## ADDENDUM NO. 1, September 30, 2020 *(Revised October 1, 2020)*

RE: POK-DIP 151C  
Project No. 2190380.01

FROM: **Mackenzie**  
The Hudson Building  
101 E 6<sup>th</sup> Street, #200  
Vancouver, WA 98660  
(360) 695-7879

**1 FLOOR PLAN**  
A1.10 1/8"=1'-0"

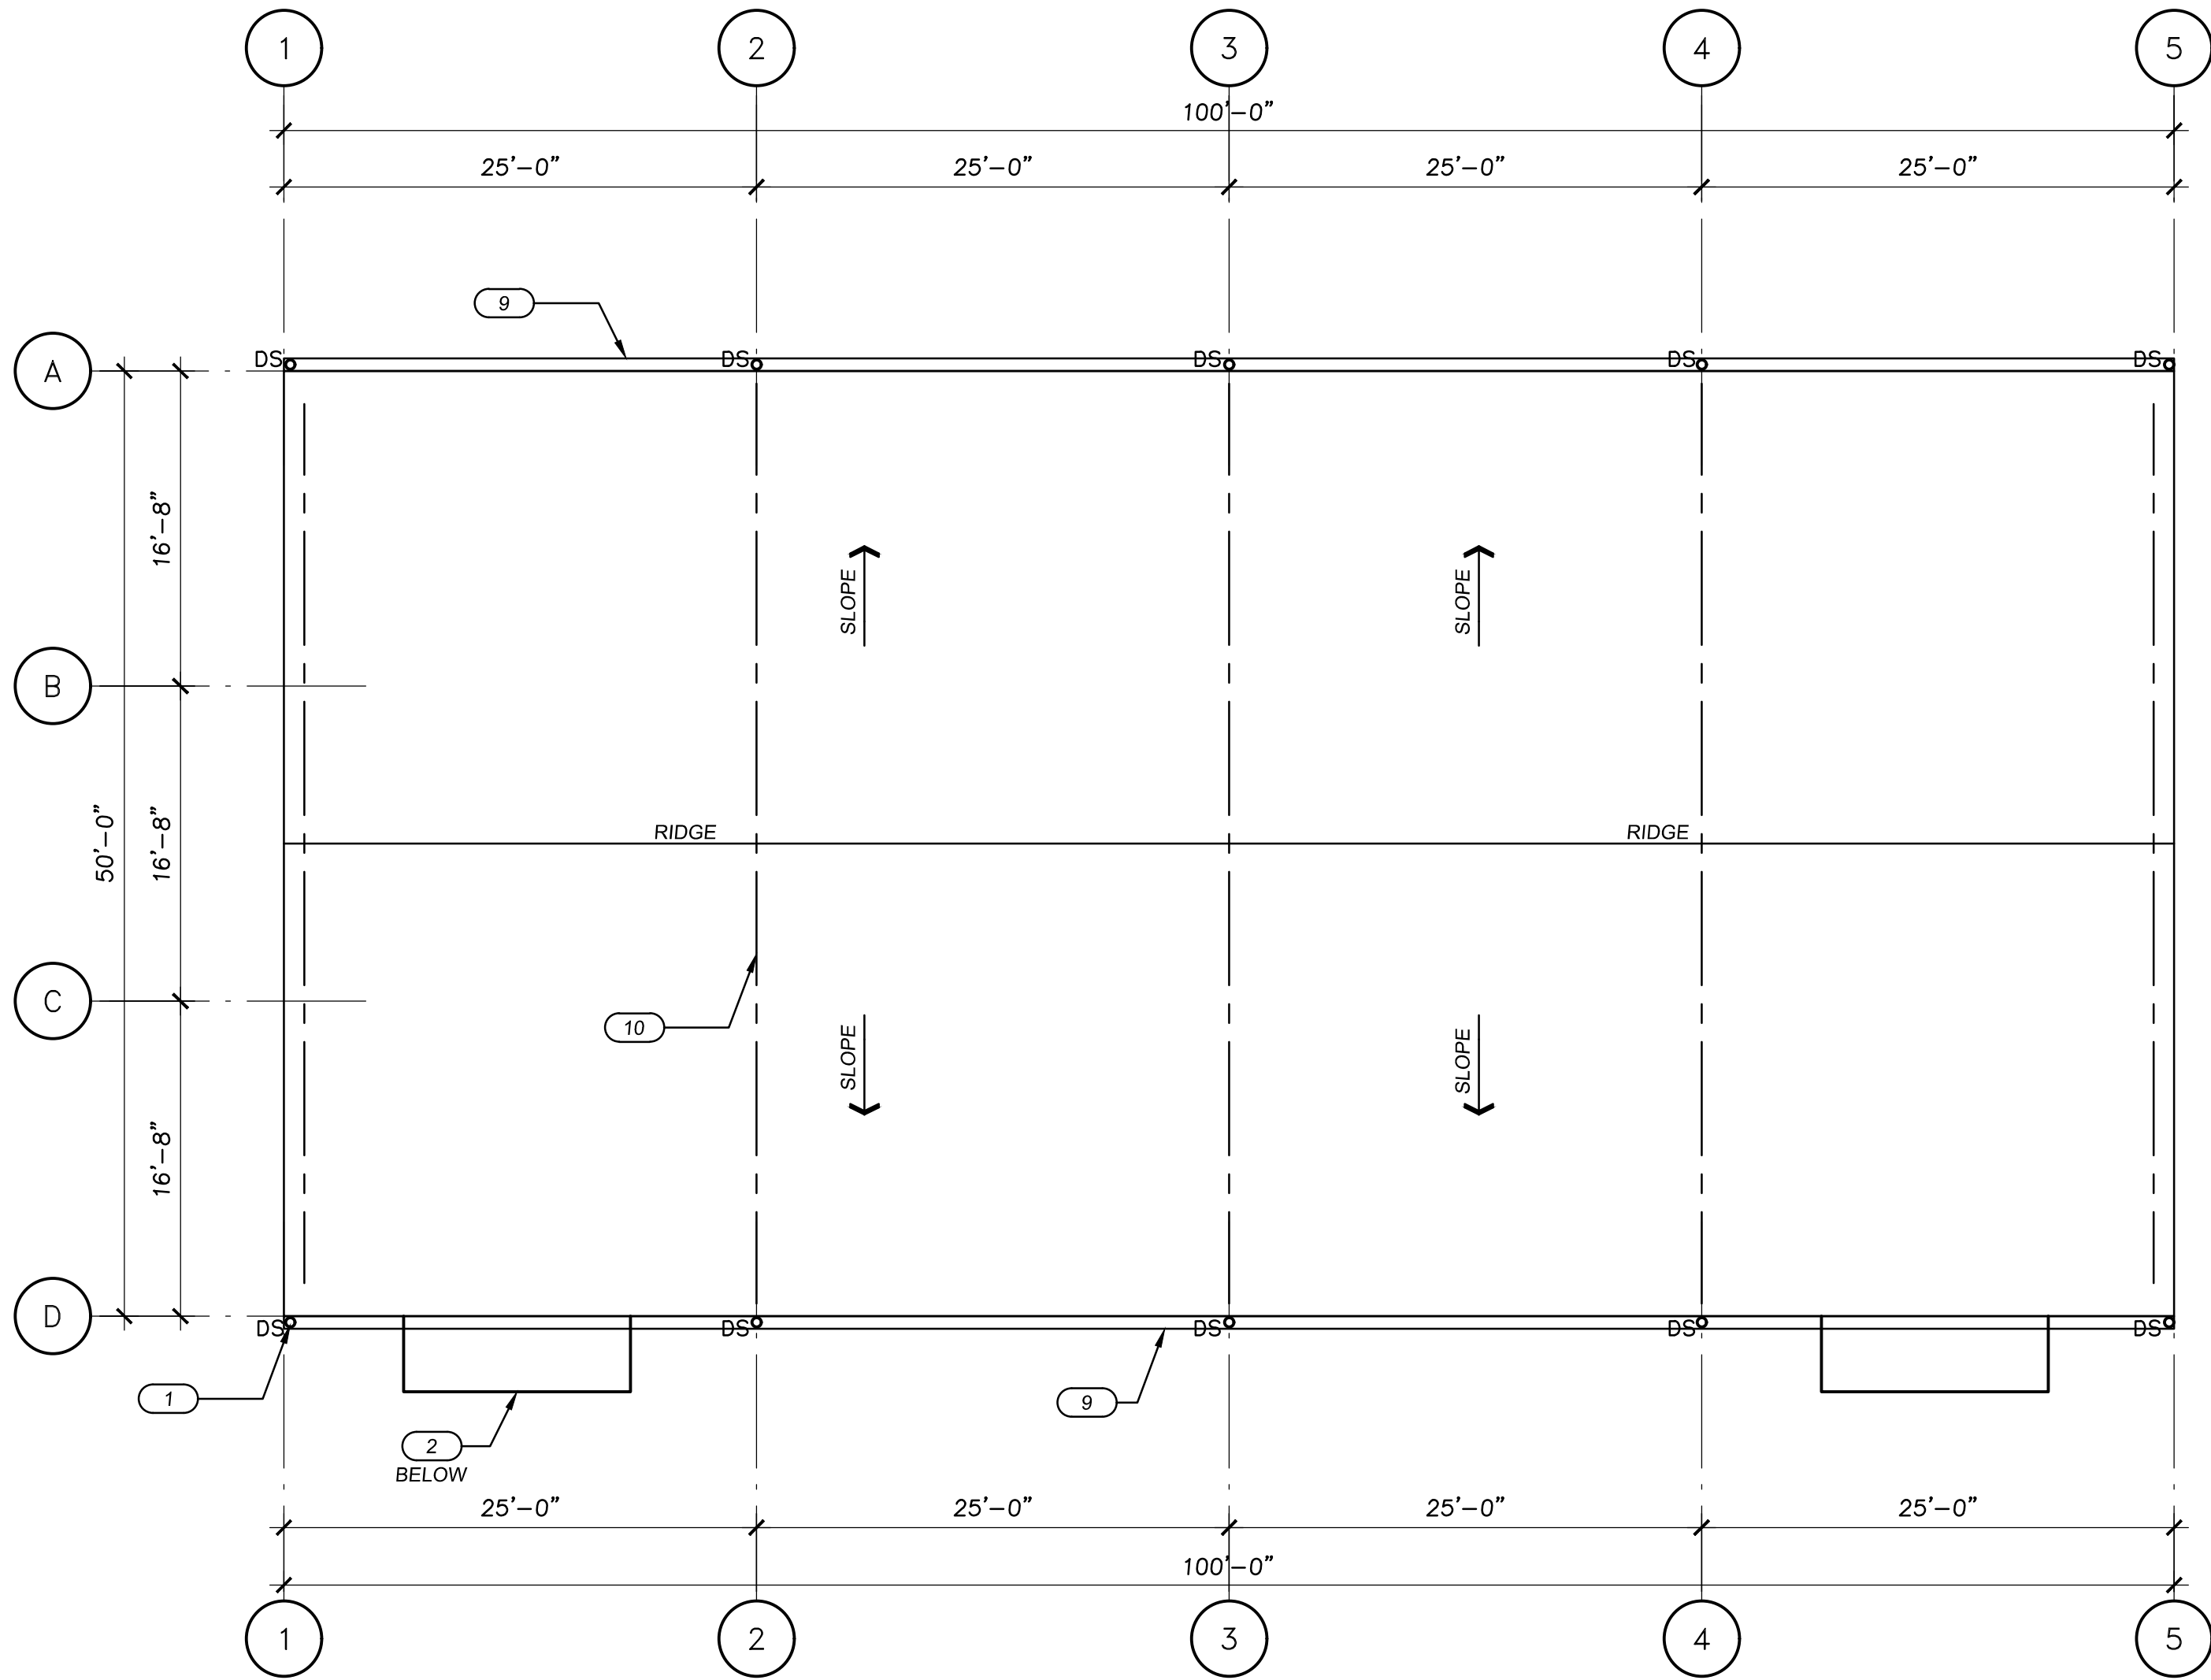
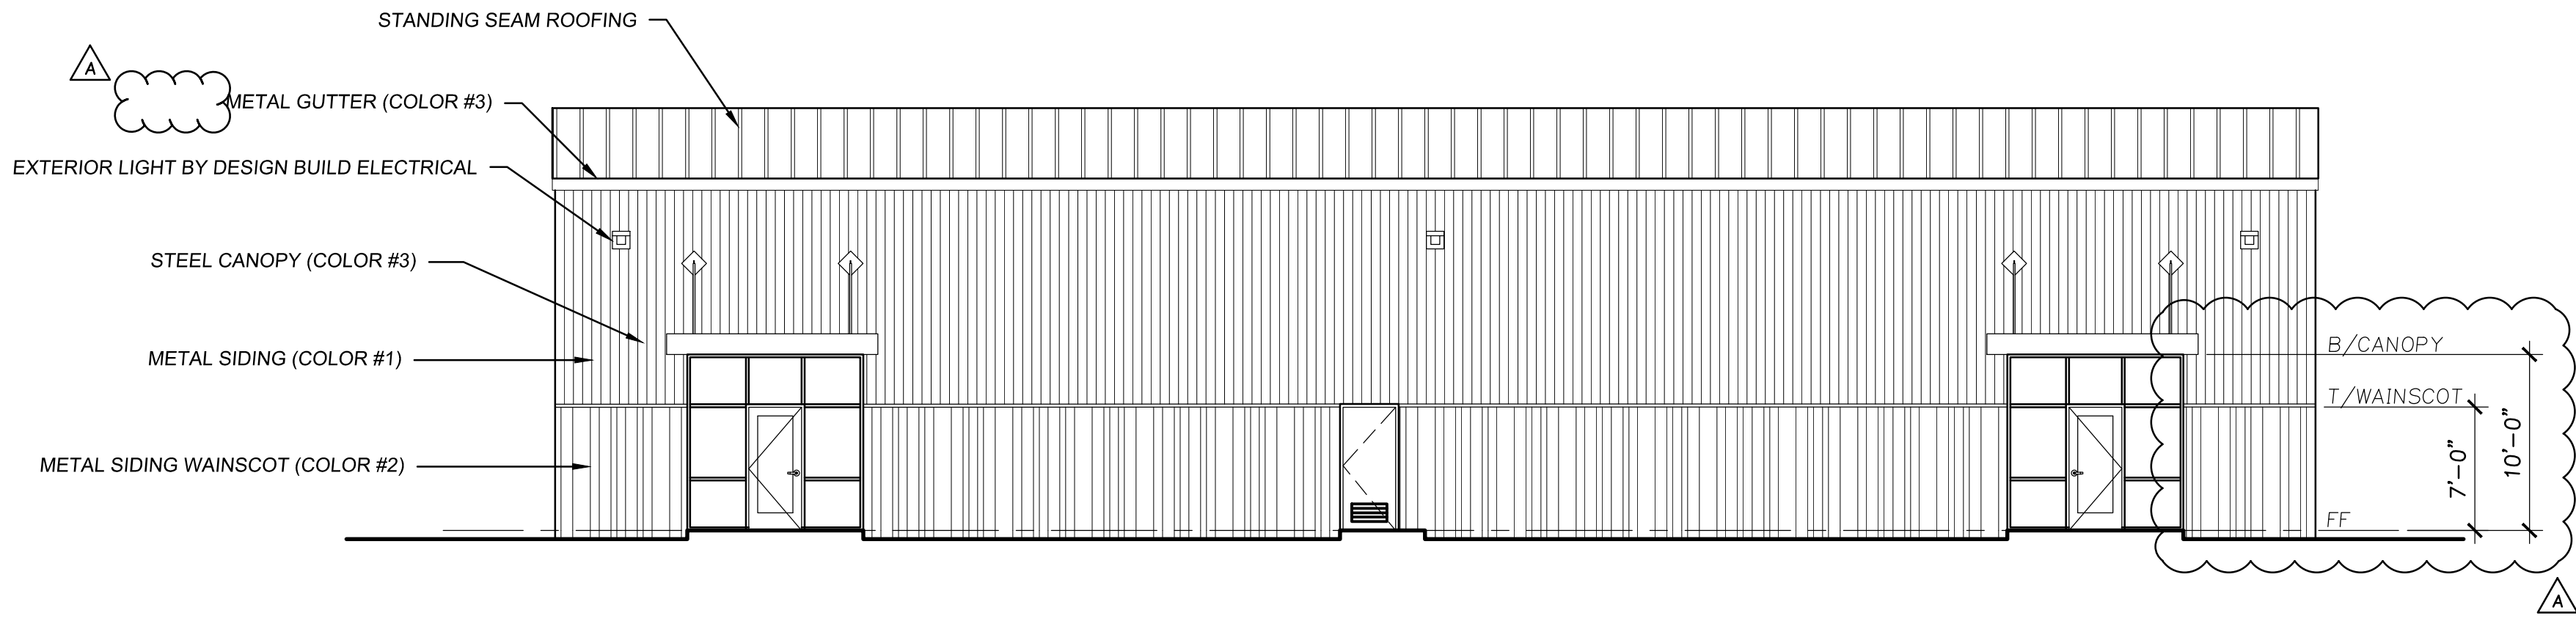
| ARCHITECTURAL DOCUMENT CHANGE LOG                                                          |                |               |               |                               |              | Mackenzie<br>1515 SE Water Ave, Ste 100, Portland OR 97214 (503) 224-9560                                                                                                                                                                                                                                                                               |
|--------------------------------------------------------------------------------------------|----------------|---------------|---------------|-------------------------------|--------------|---------------------------------------------------------------------------------------------------------------------------------------------------------------------------------------------------------------------------------------------------------------------------------------------------------------------------------------------------------|
| A1.10                                                                                      | ADDENDUM #1    | A             | 9/30/2020     | 3                             | 1,2,3        | REVISED DOWNSPOUT SIZE AND GUTTER SIZE.                                                                                                                                                                                                                                                                                                                 |

1 SOUTH ELEVATION  
A2.10 1/8"=1'-0"

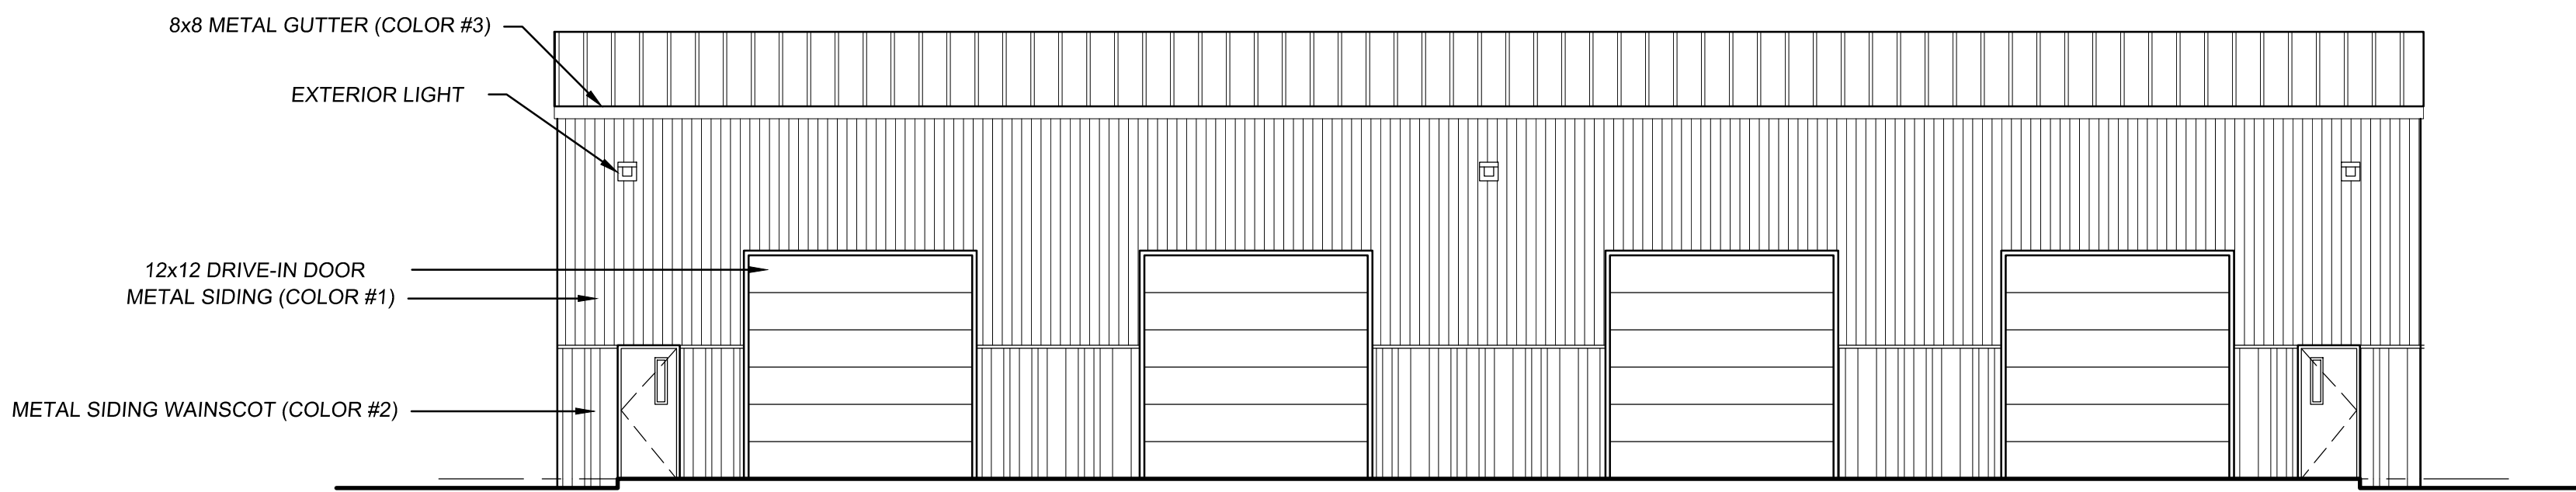
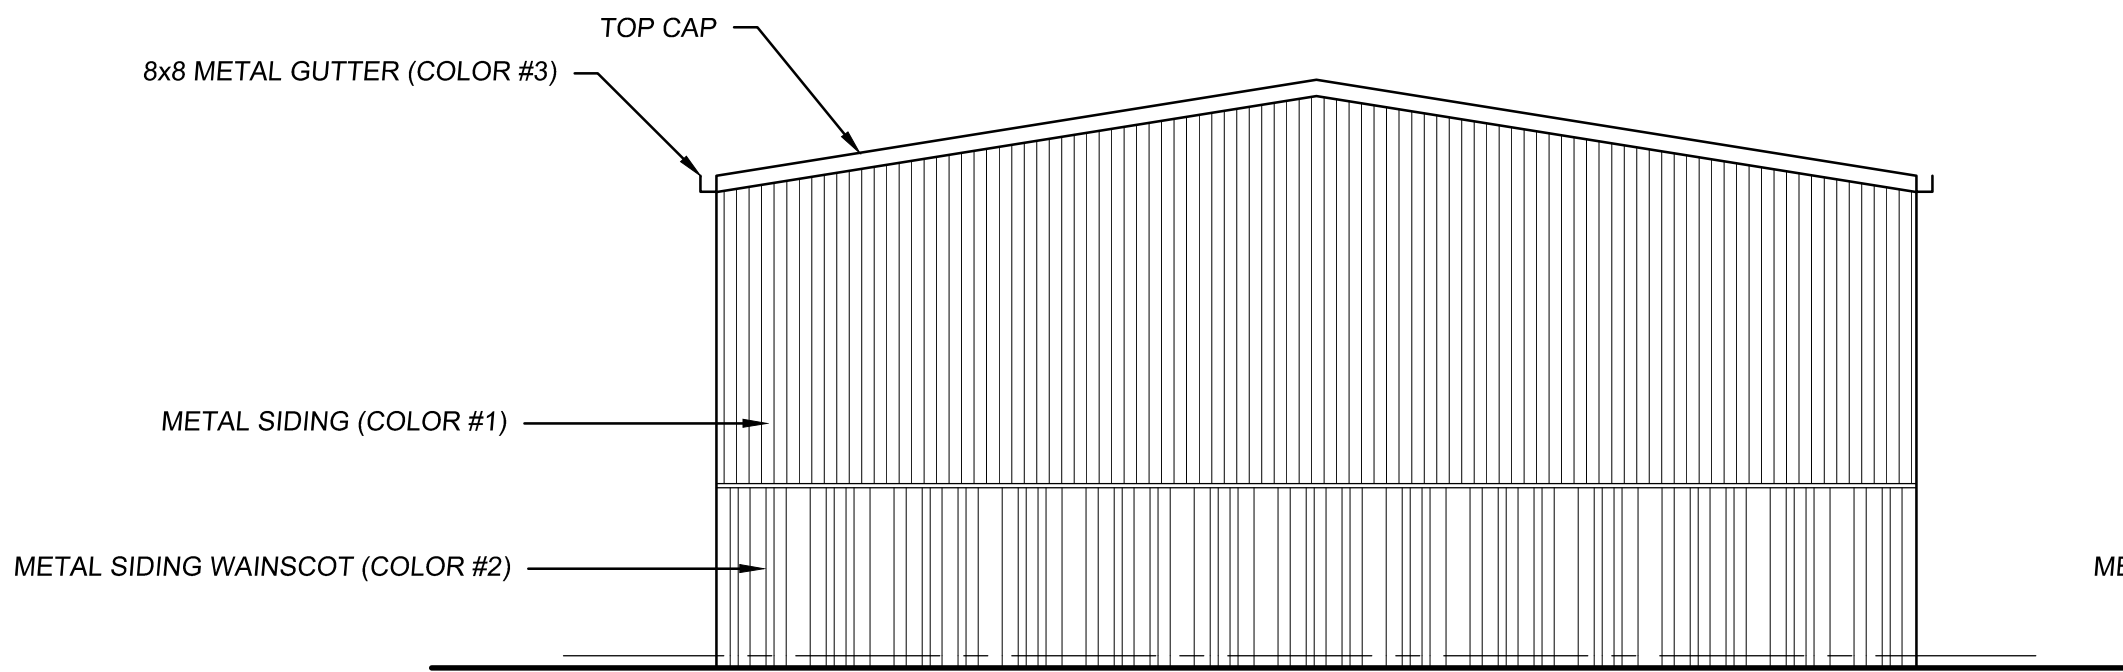
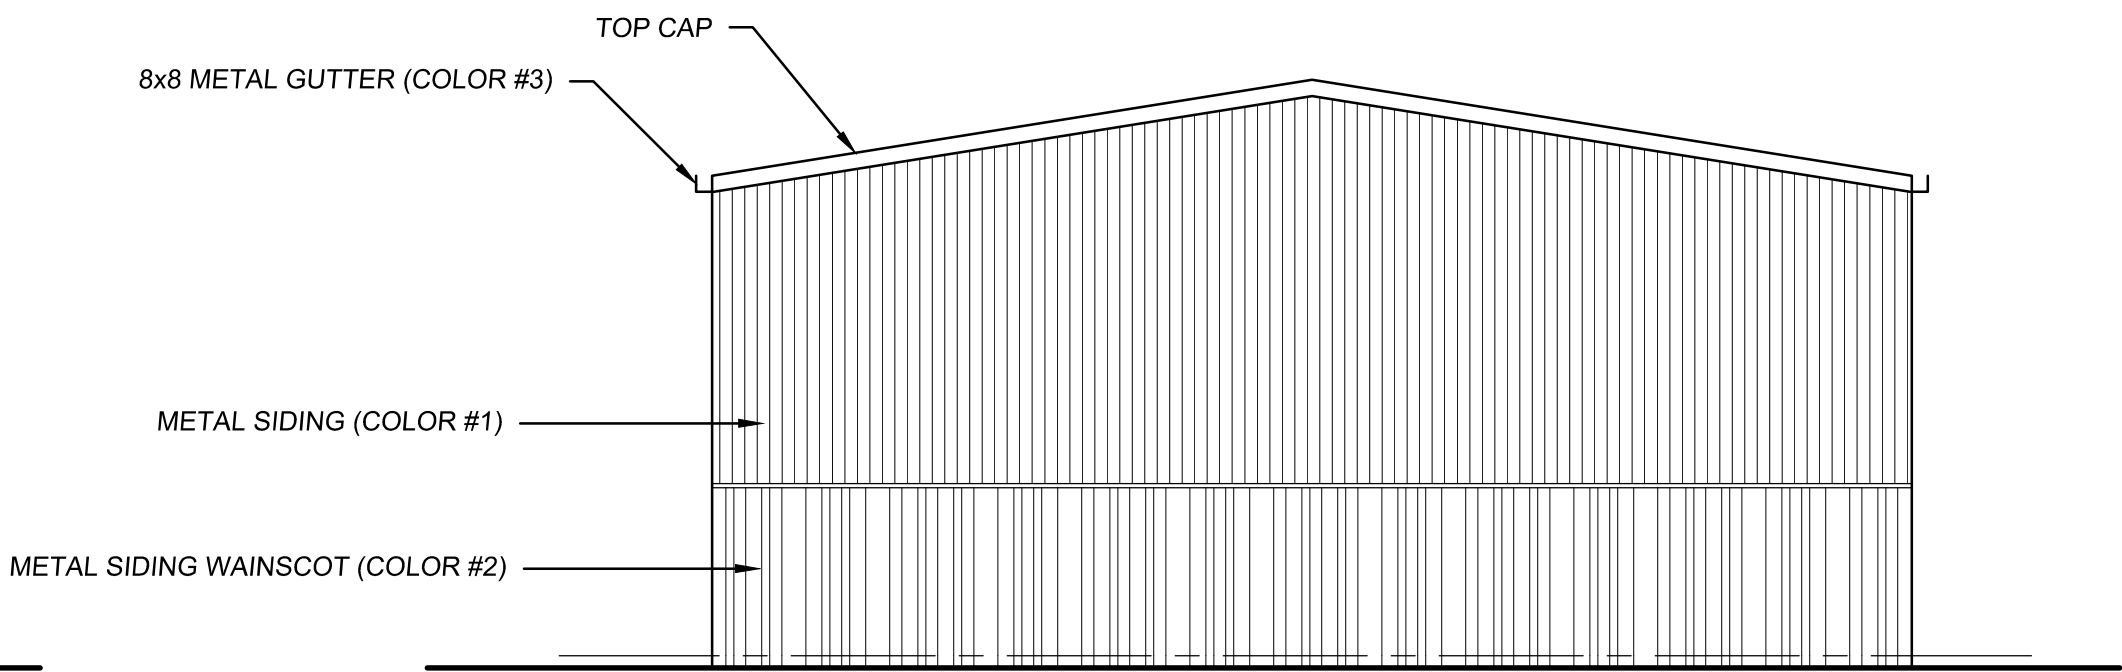
- A. Office areas will be provided at future tenant improvement, furring at toilet room only, see detail 3/A5.20. Note Y from A0.01 has been removed.
39. Drawing A2.10, please verify the bottom elevation of these two canopies is 110 ft AFF.

- A. Confirmed, see revised A2.10.
40. Drawing A2.10, please verify the elevation (from finish floor 100'-0") of the metal panel wainscot.
- A. Wainscot to be at 107'-0" above finished floor. See revised A2.10

| ARCHITECTURAL DOCUMENT CHANGE LOG                                                          |                |               |               |                               |              | Mackenzie<br>1515 SE Water Ave, Ste 100, Portland OR 97214 (503) 224-9560                                                                                                                                                                                                                                                                               |
|--------------------------------------------------------------------------------------------|----------------|---------------|---------------|-------------------------------|--------------|---------------------------------------------------------------------------------------------------------------------------------------------------------------------------------------------------------------------------------------------------------------------------------------------------------------------------------------------------------|
| A2.10                                                                                      | ADDENDUM #1    | A             | 9/30/2020     | 3                             | 1,2,3        | ADDED DIMENSION FOR CANOPY AND WAINSCOTTING                                                                                                                                                                                                                                                                                                             |
